AV Lite Proposal

To: T13 Technical committee
From: Jim Hatfield
 Seagate Technology
 389 Disc Drive
 Longmont, CO 80503
 Phone: 720-684-2120
 Fax: 720-684-2711
 Email: James.C.Hatfield@seagate.com
Date: *January 13, 2003*

- *Dec. 18, 2002 - Approved by T13*
- *Jan. 13, 2003*
 - *TBD values assigned by T13*
 - *Minor clarifications added*
 - *Set DWE if Stream Error occurs during a write or flush command*

Figure 1

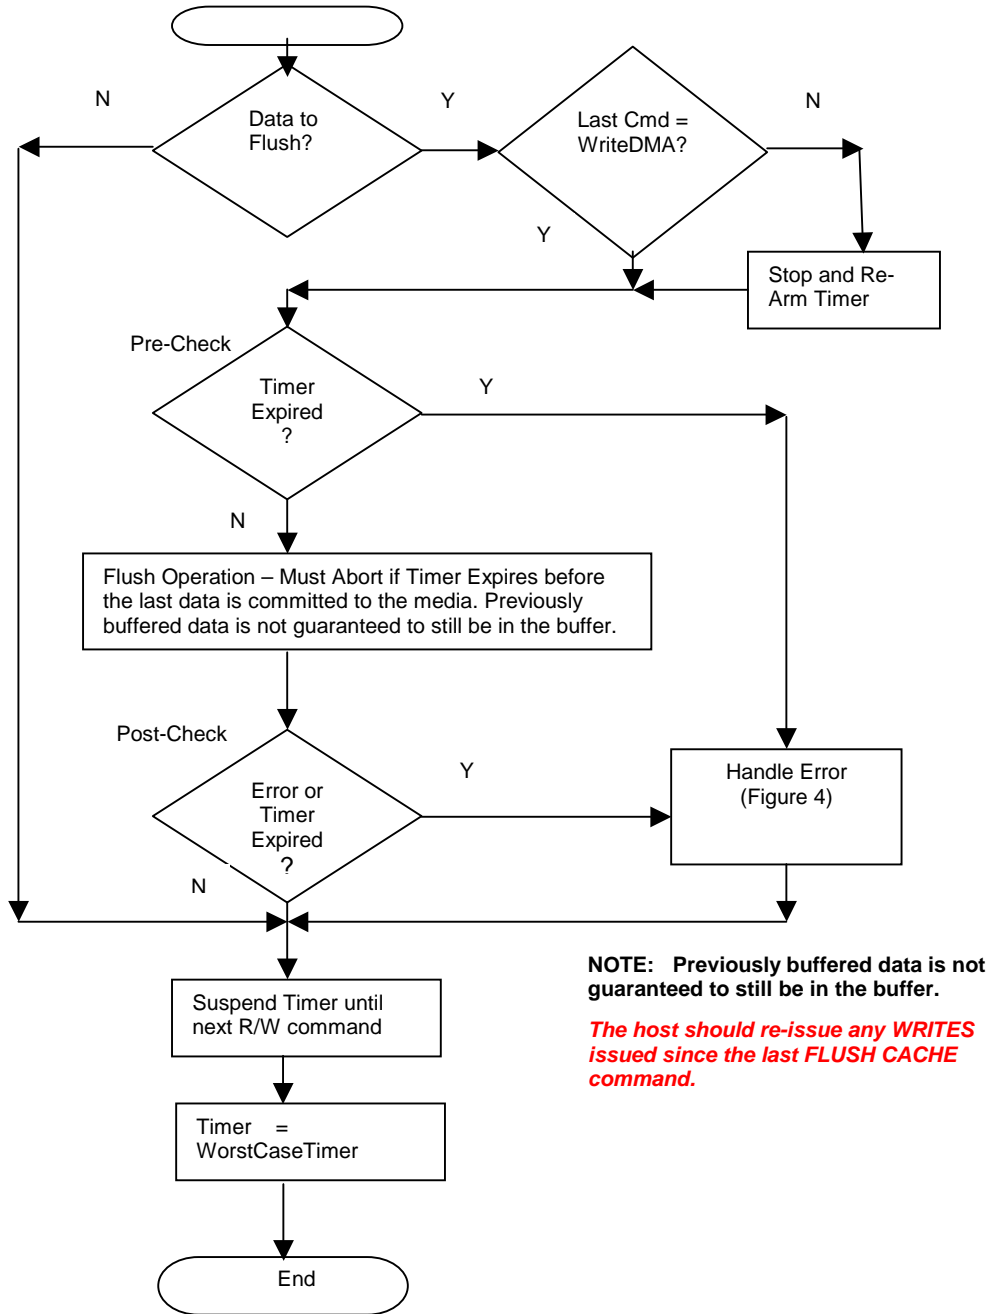
2.4 FLUSH CACHE Changes

If A/V Lite is supported and enabled, the following algorithm shall be used:

Figure 2

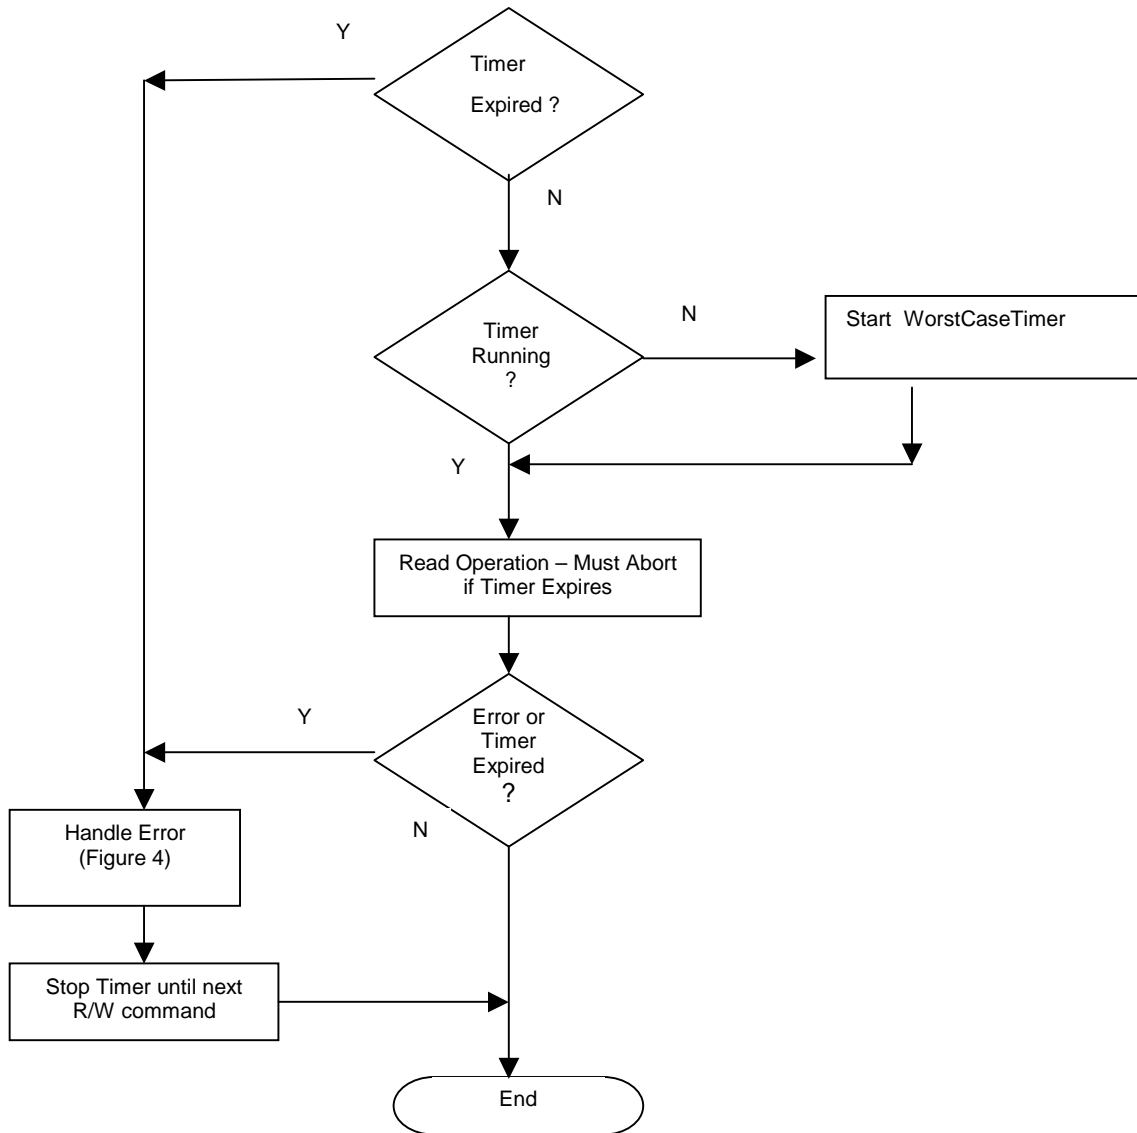
2.5 READ DMA and READ DMA EXT command changes

If A/V Lite is supported and enabled, the following algorithm shall be used:

Figure 3

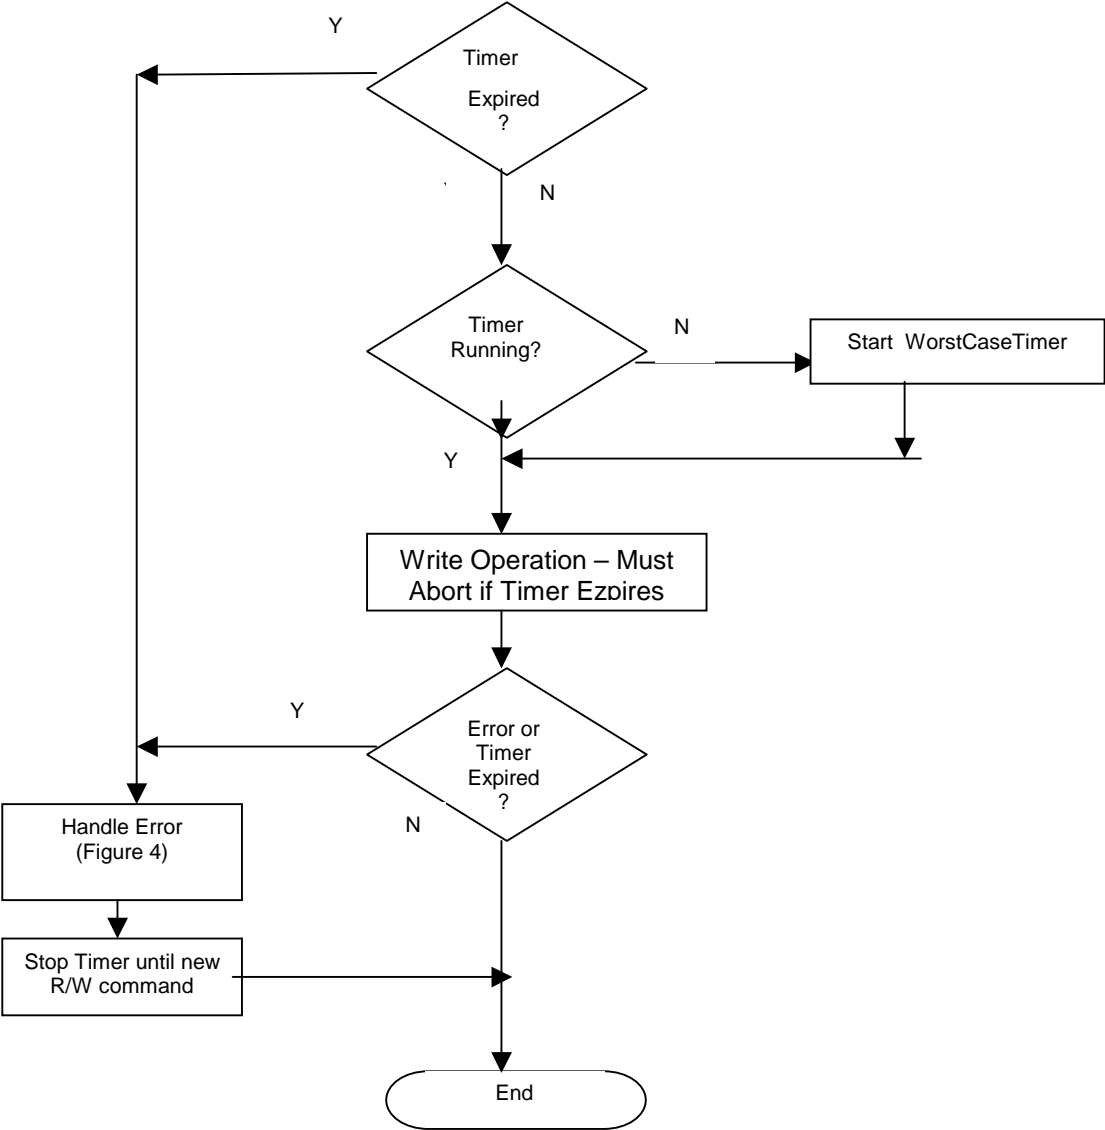
2.6 WRITE DMA and WRITE DMA EXT command changes

If A/V Lite is supported and enabled, the following algorithm shall be used:

Figure 4

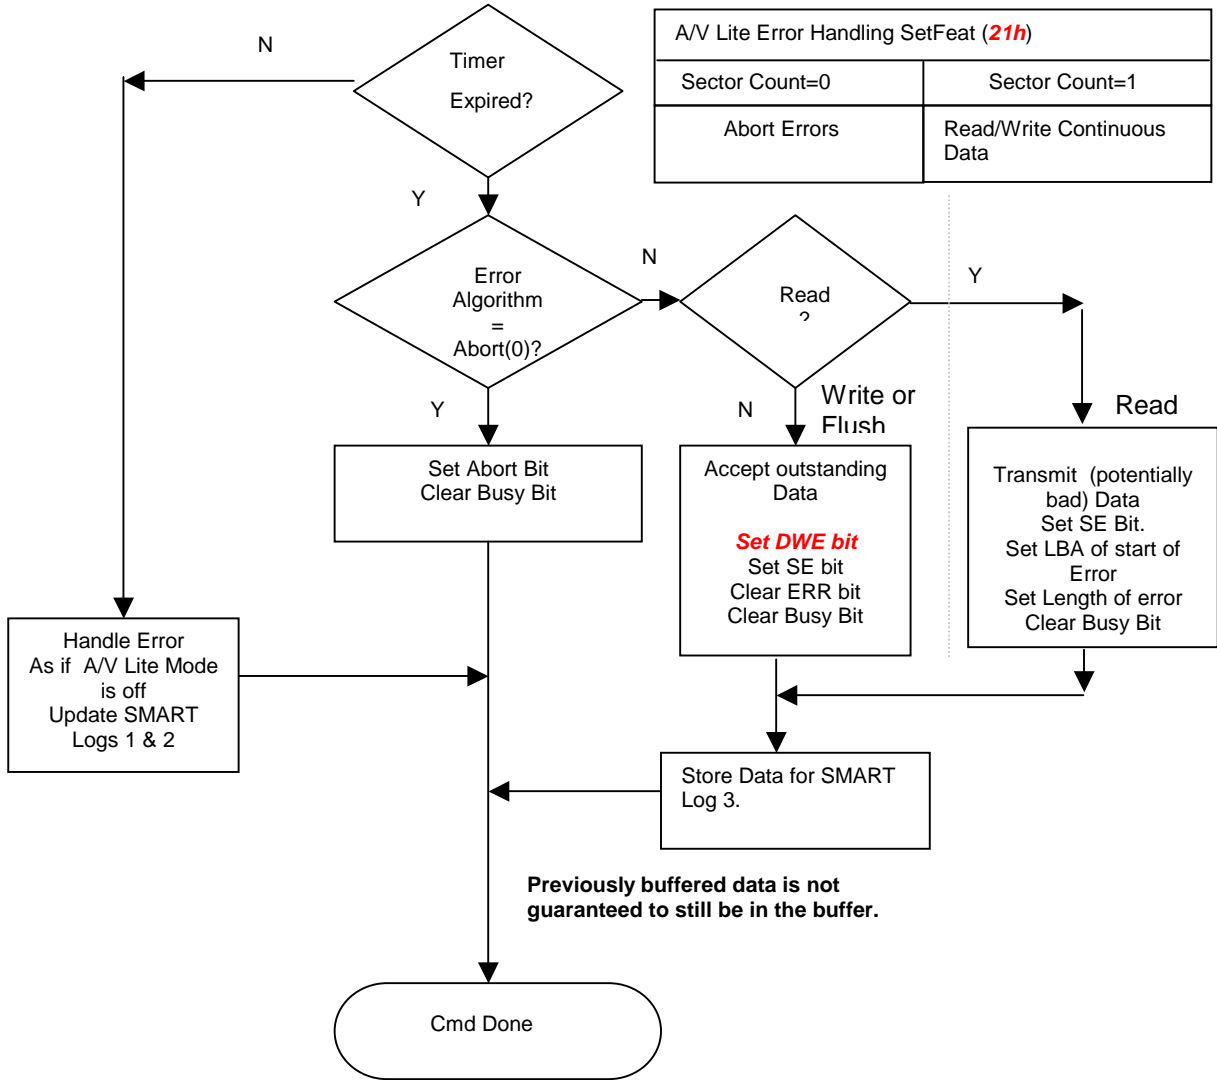
2.7 ERROR HANDLING

Two error handling algorithms are supported:
 Abort the Command and report the LBA of the Aborted Command; or
 Transfer “garbage” data if data is not currently available.

The algorithms are selected via the Set Features Command –
 Features Register = **20h** and **21h**
